## Attestation

### Re: New application FCC: KA2CS8325LHA1

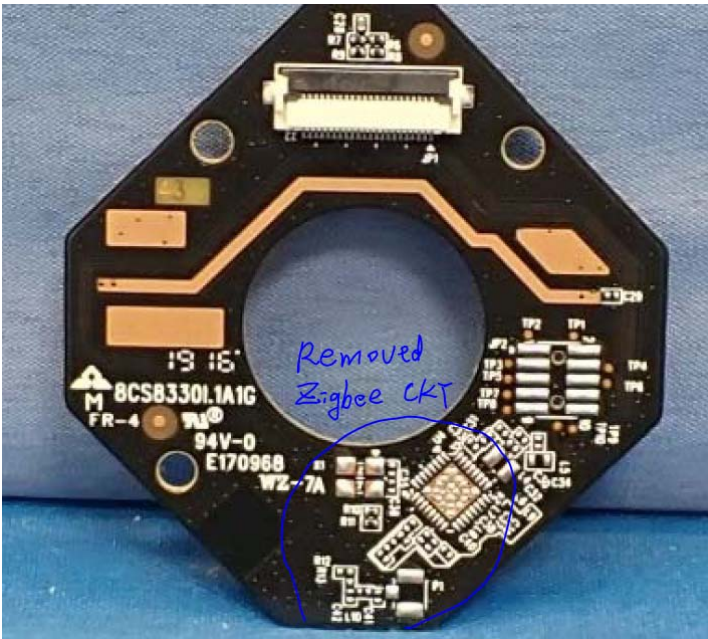
1. **Remove Zigbee hardware:** There are a total of two PCB boards, and ZigBee is located on first PCB board as shown below.
